SERVICE LETTER

No. 630

Piper Aircraft Corporation

Subject: Lubrication of Fuel Valve Selector Mechanism

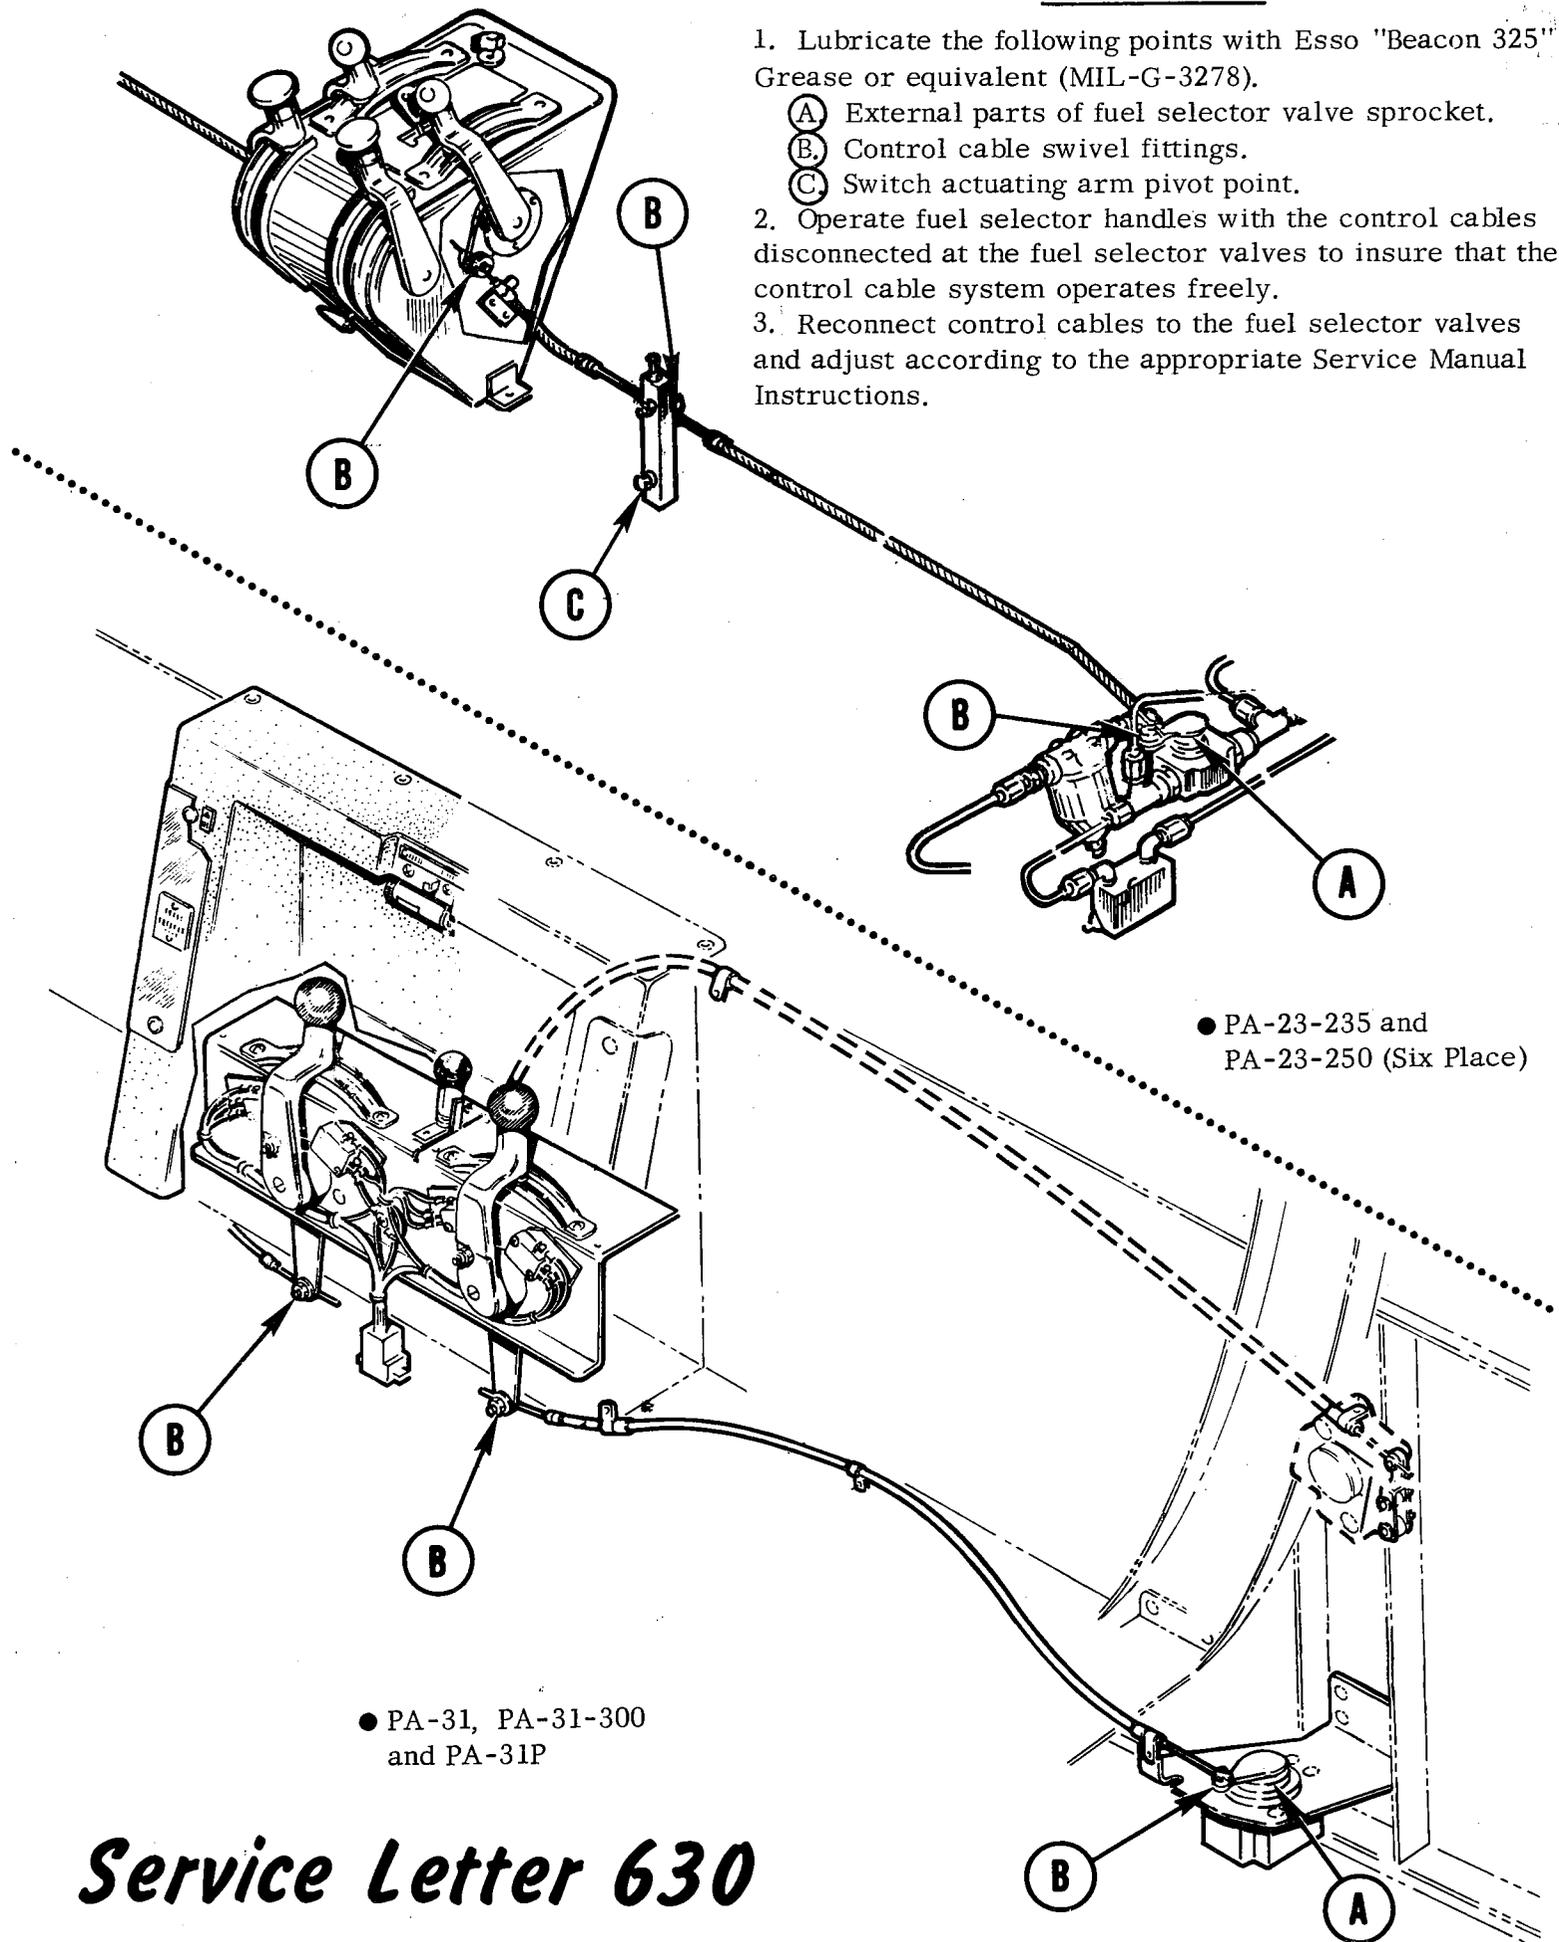
1. Lubricate the following points with Esso "Beacon 325" Grease or equivalent (MIL-G-3278).

- (A) External parts of fuel selector valve sprocket.
- (B) Control cable swivel fittings.
- (C) Switch actuating arm pivot point.

2. Operate fuel selector handles with the control cables disconnected at the fuel selector valves to insure that the control cable system operates freely.

3. Reconnect control cables to the fuel selector valves and adjust according to the appropriate Service Manual Instructions.
